STAGE 3 SUBMITTAL - JULY 23, 2025

REVIEW COMPLETE

PROJECT DESCRIPTION  
THE PROJECT INVOLVES THE CONSTRUCTION OF NEW SIDEWALKS ON BOTH SIDES OF SPRINGDALE ROAD FROM POOLE ROAD TO YELLOWWOOD DRIVE.

PROJECT ID  
120861

TITLE SHEET

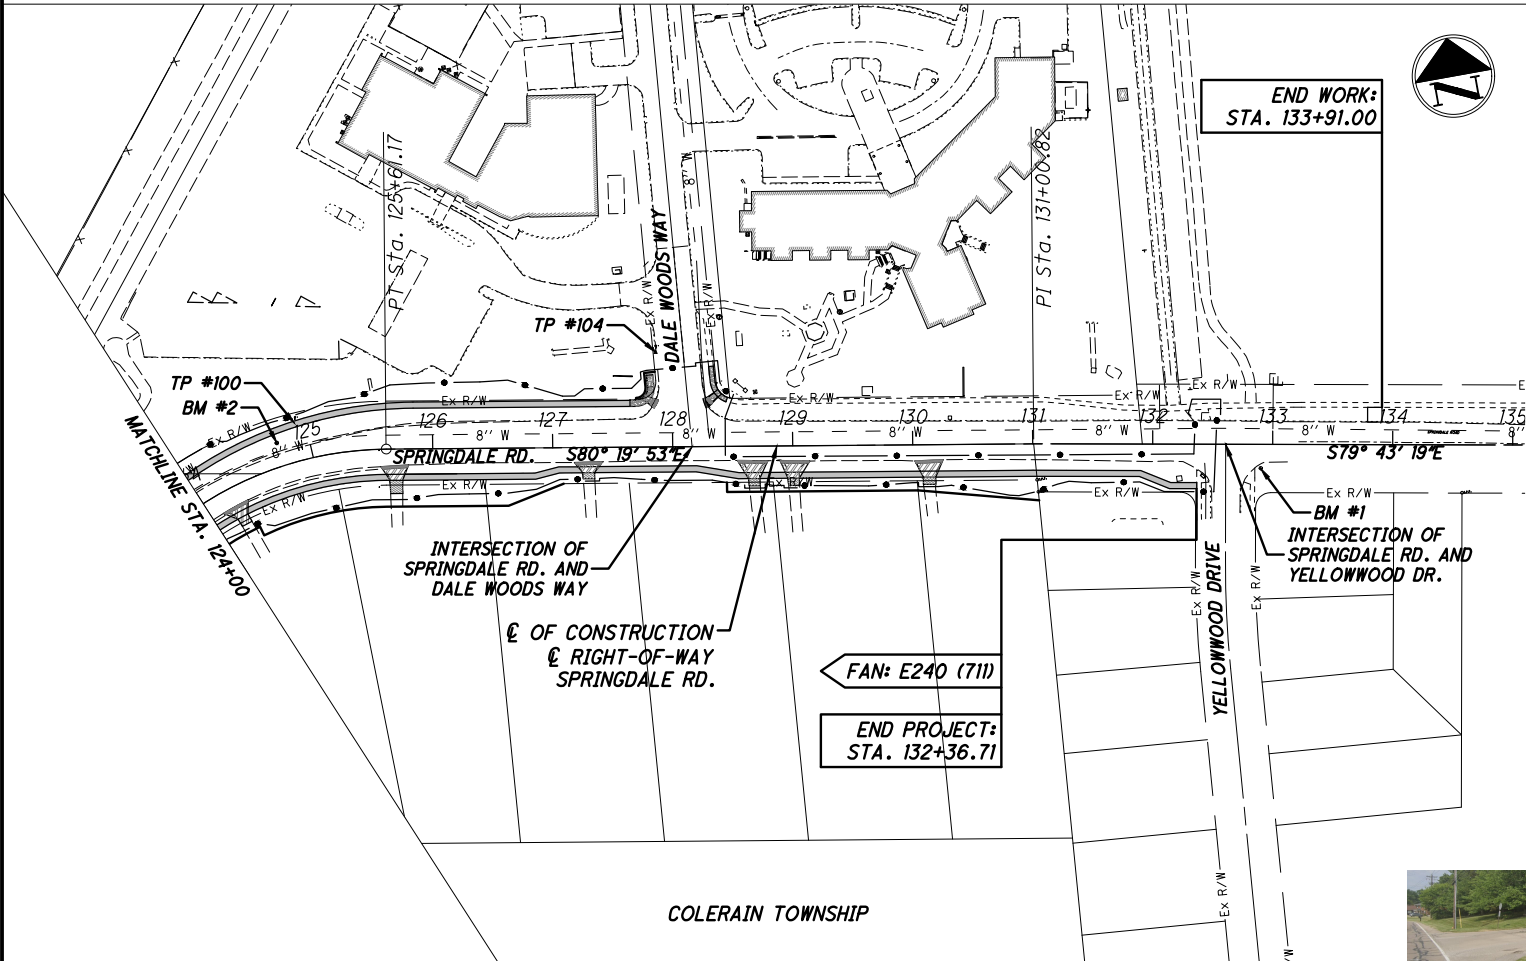
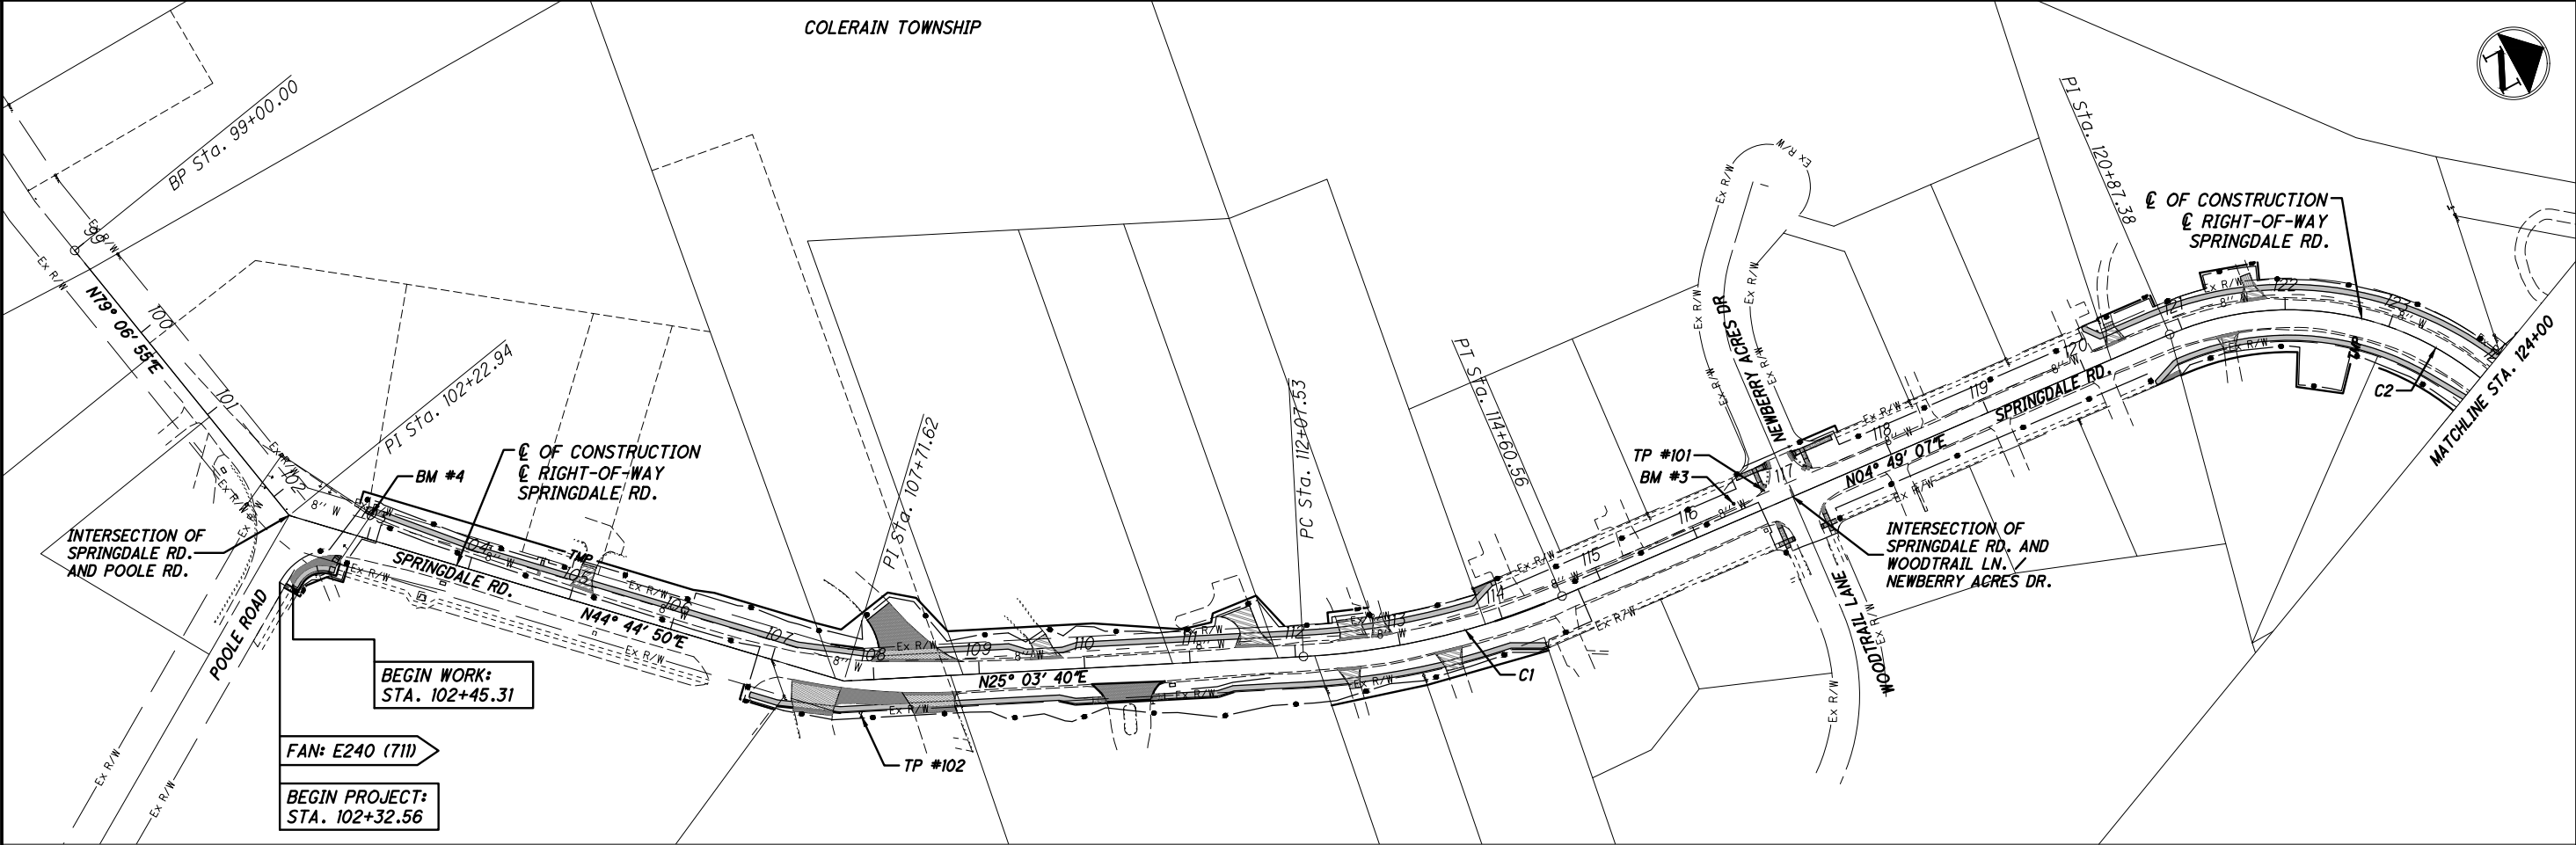
All associated  
SCD/SS dates  
should be filled in at  
this point.

comments were made on  
the BMP calcs

That's now at  
Stage 3.

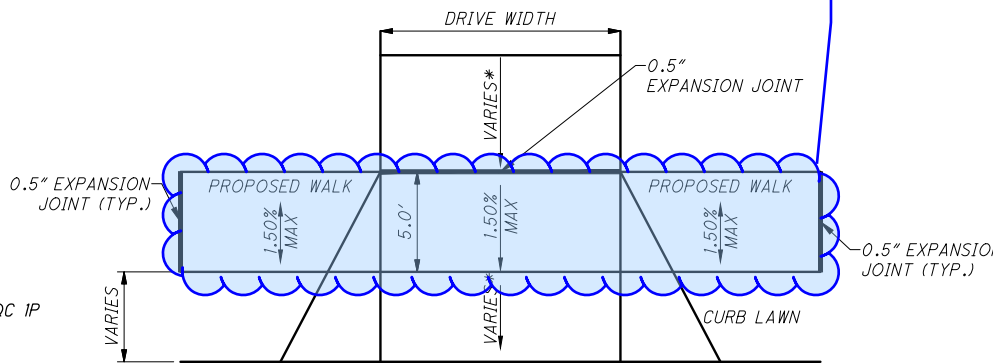
Add Item 204 subgrade compaction for sidewalks.

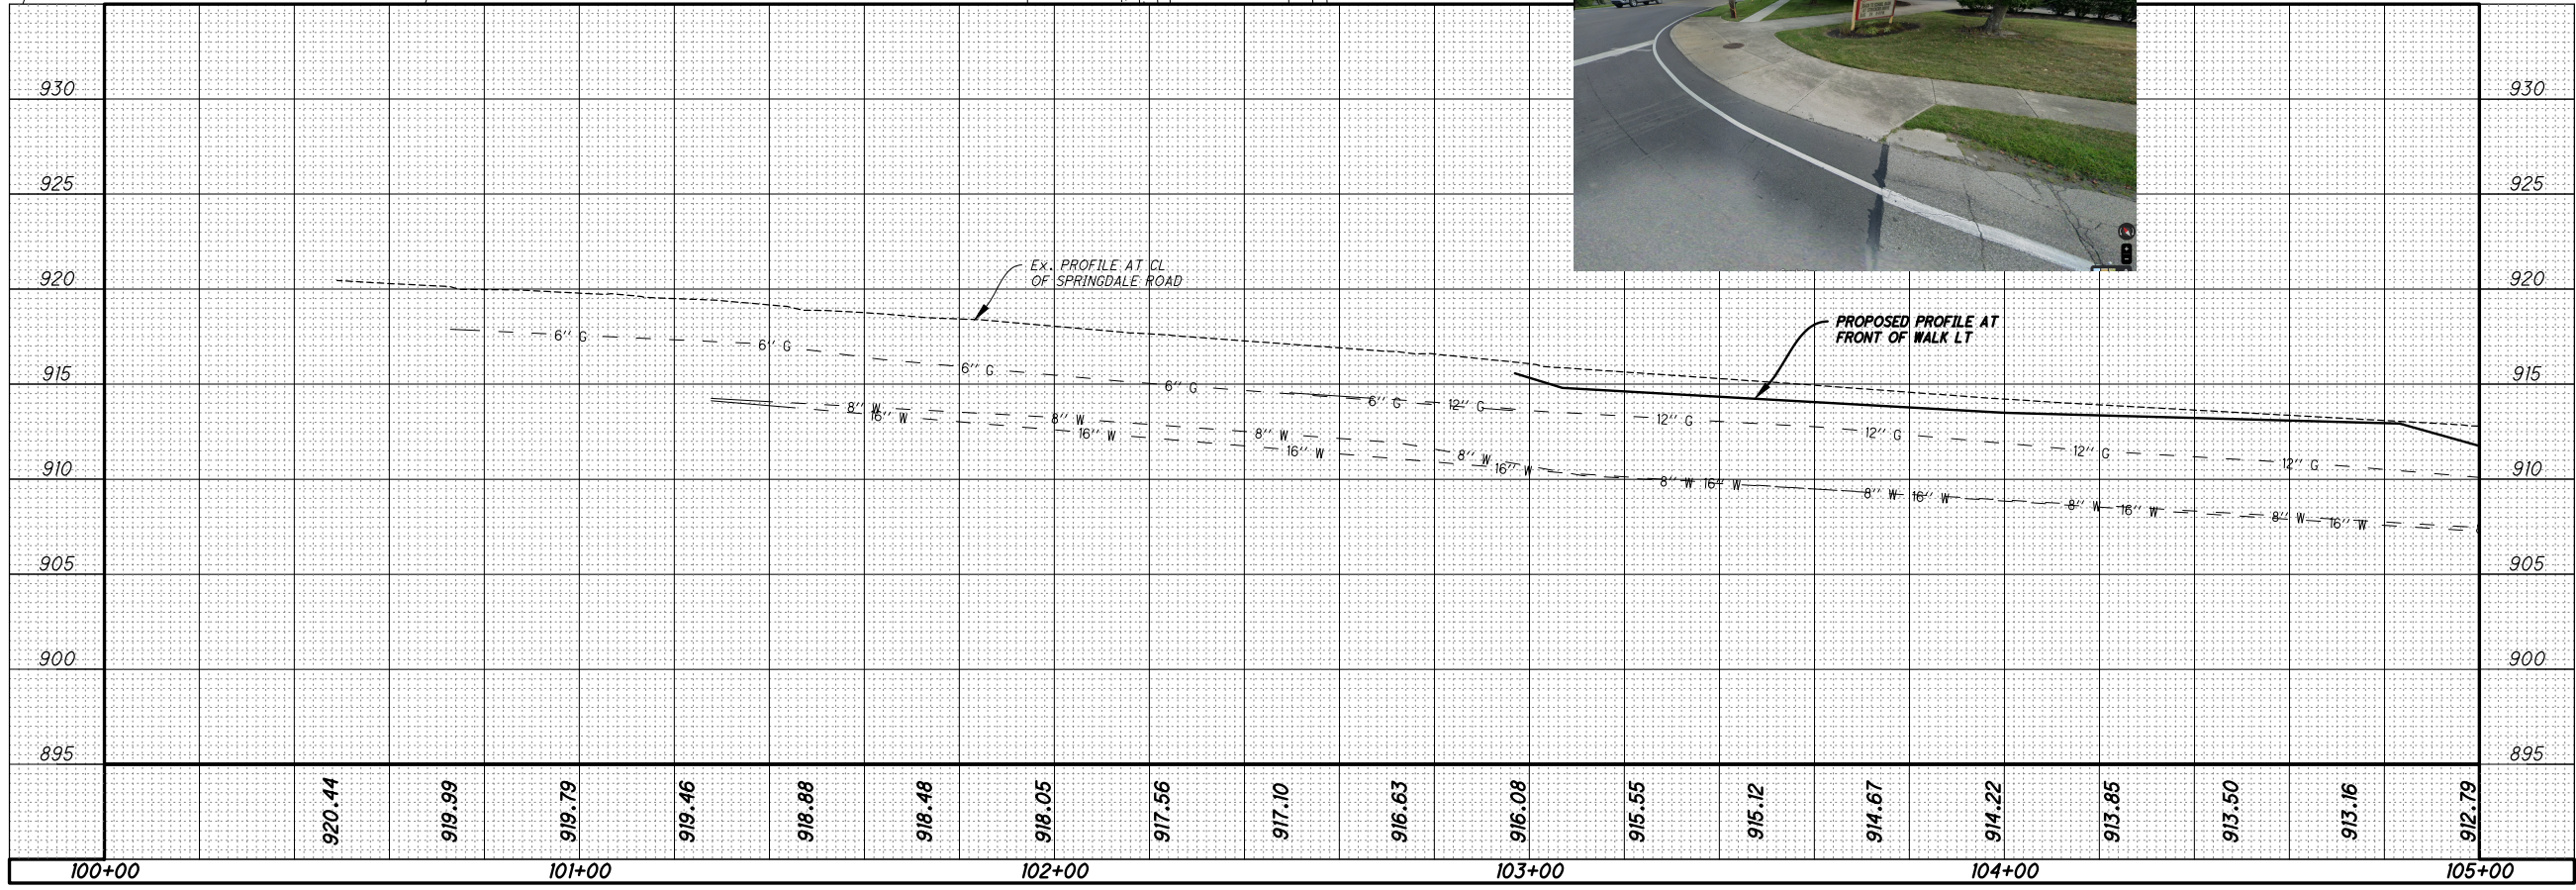
add the gold hatching for the

PLAN AND PROFILE - SPRINGDALE ROAD  
STA. 100+00 to STA. 105+00

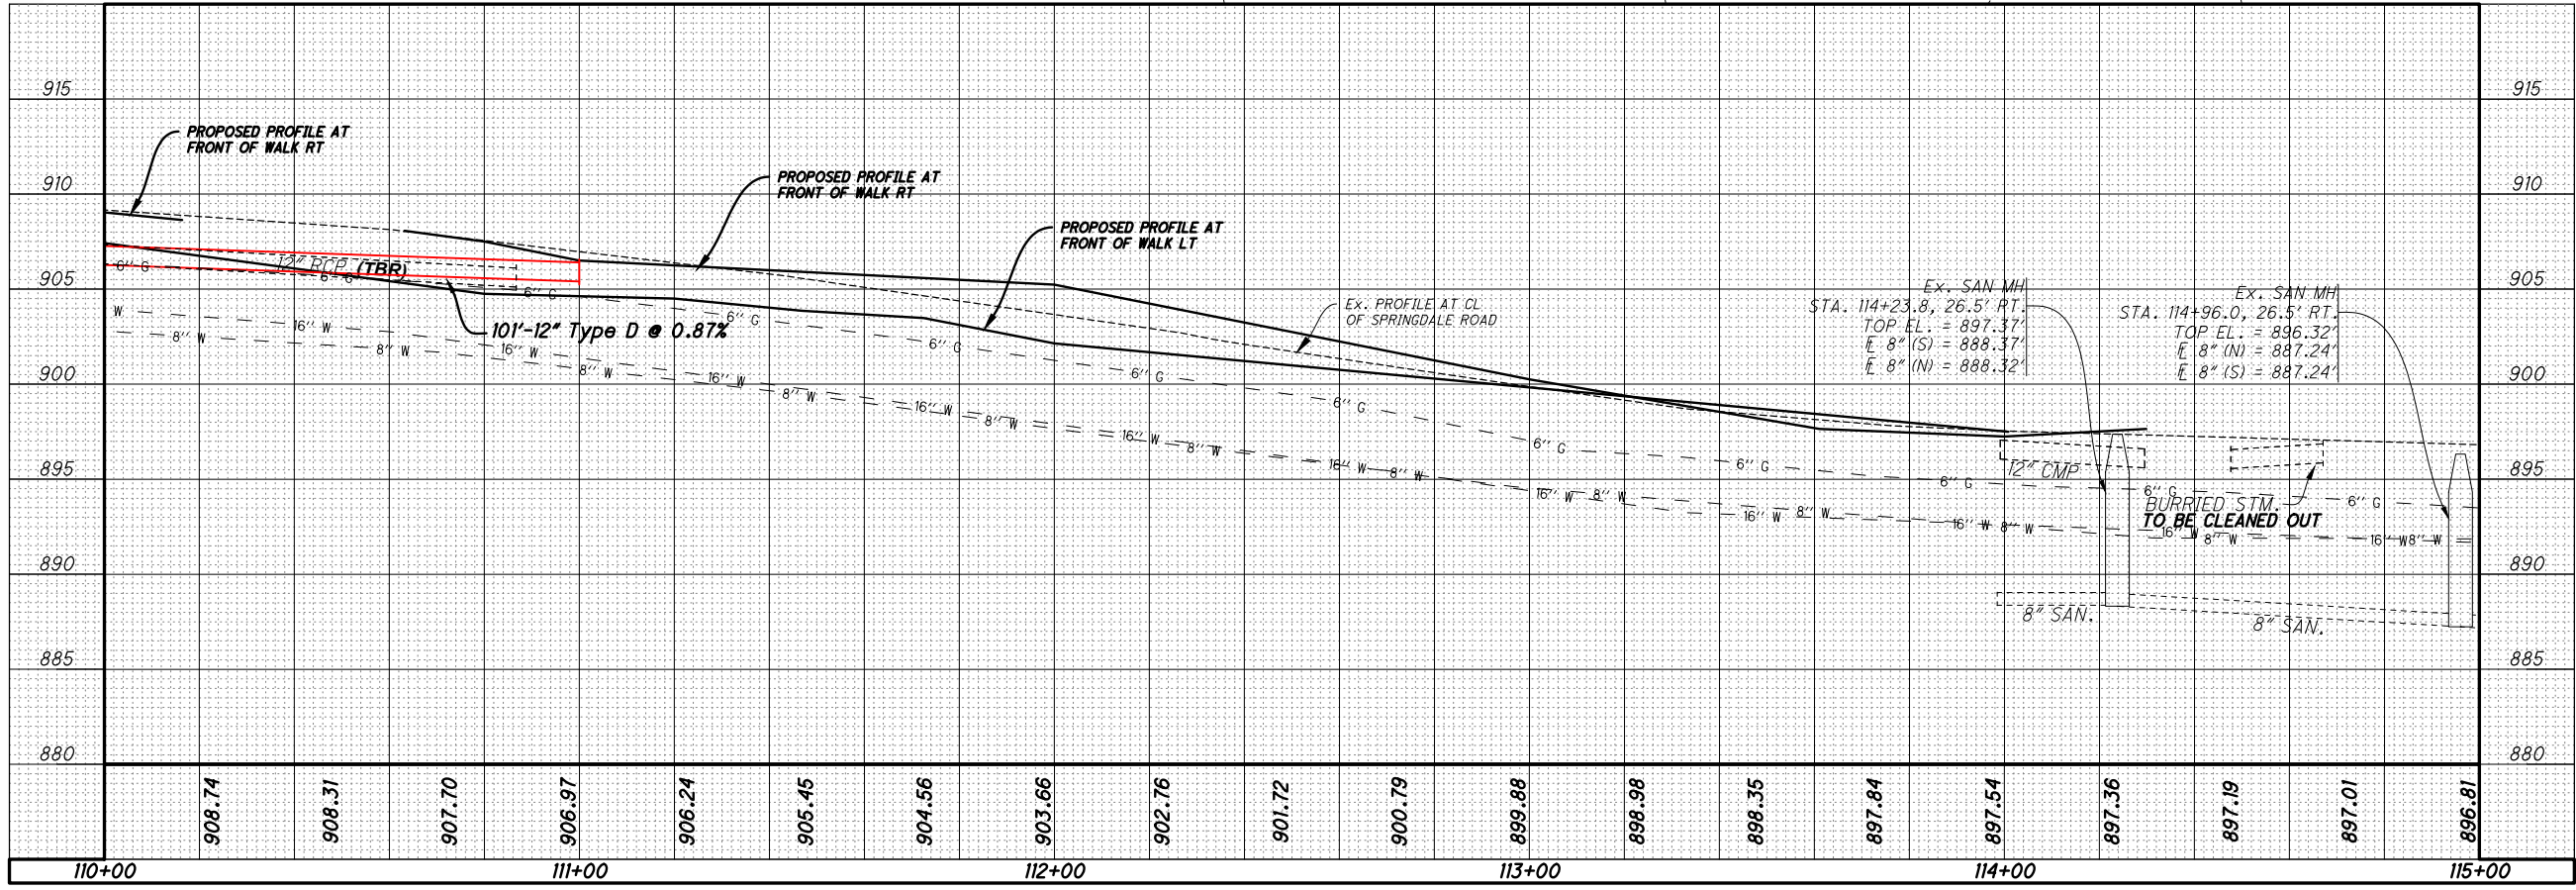
This proposed grass area will  
become damaged and rutted by  
turning vehicles. Consider  
installing curb around the radius.  
Would have to add some  
pavement repair quantity as well.
